RECEIPT DATE: 5/25/21 **ONSITE SEWAGE DISPOSAL SYSTEM**

APPROVAL DATE: 05/26/2021 **PERMIT: CONSTRUCTION**

PROPERTY ADDRESS: 15613 LINDEN GROVE LANE, WOODBINE, MD 21797

SUBDIVISION: LINDEN GROVE, PHASE 1 LOT: 3 TAX ID: 04-601882

15613 Linden Grove Ln
NOT TO SCALE 1" = 30'

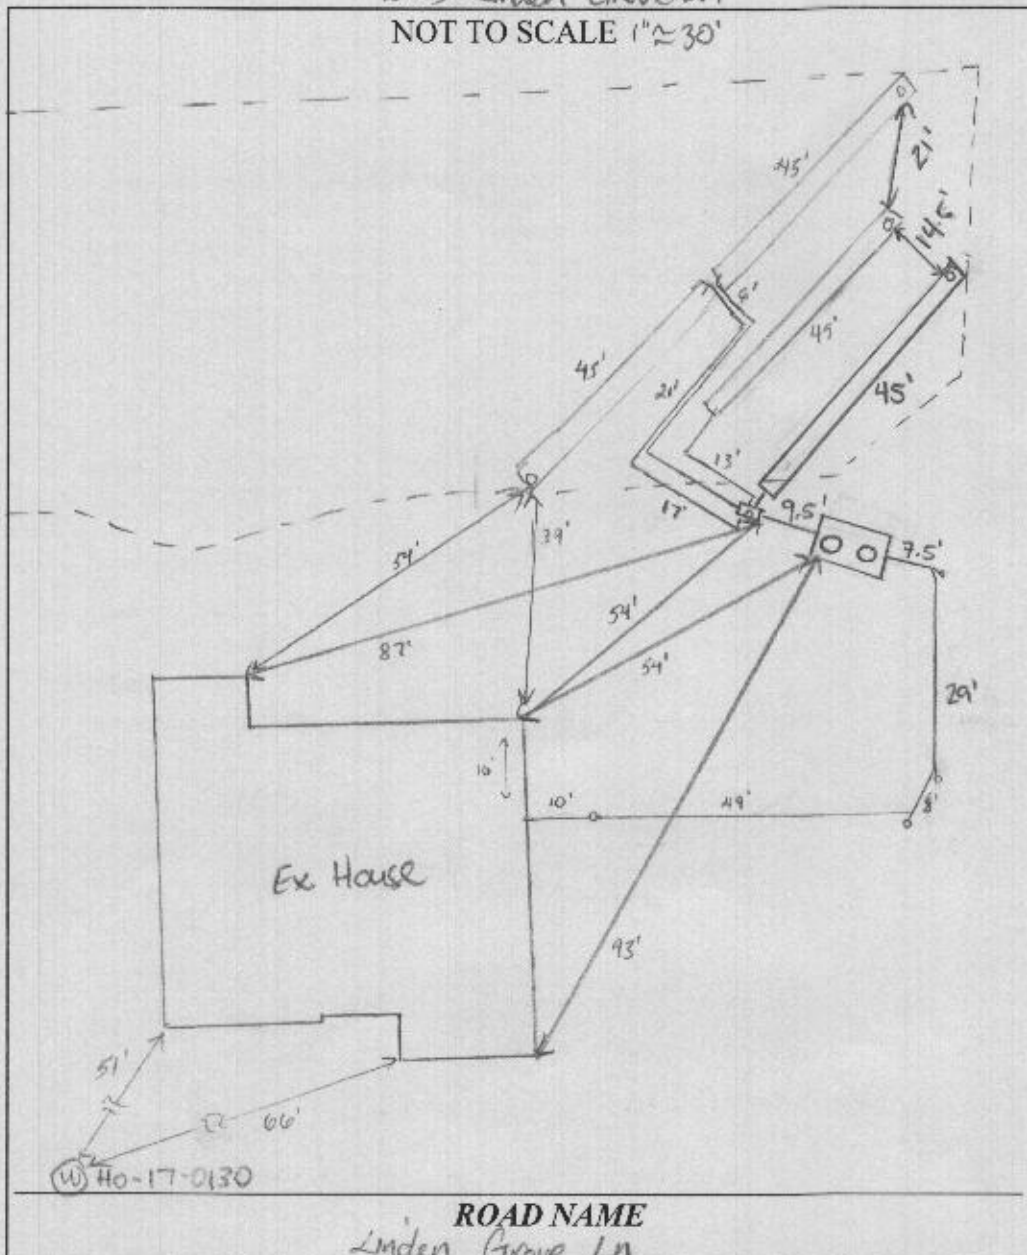
6/22/21 4x43' trenches were staked out on contour. (SR)

7/15/21 SL partially installed. Re-insp for SHC. (SD)

07/16/2021 TANK AND UPPER TRENCH SET, D BOX SET. (P)

07/19/2021 Second trench and top of long trench complete. Re-insp for lower trench. (SR) 07/20/2021 OK TO BACKFILL. (P)
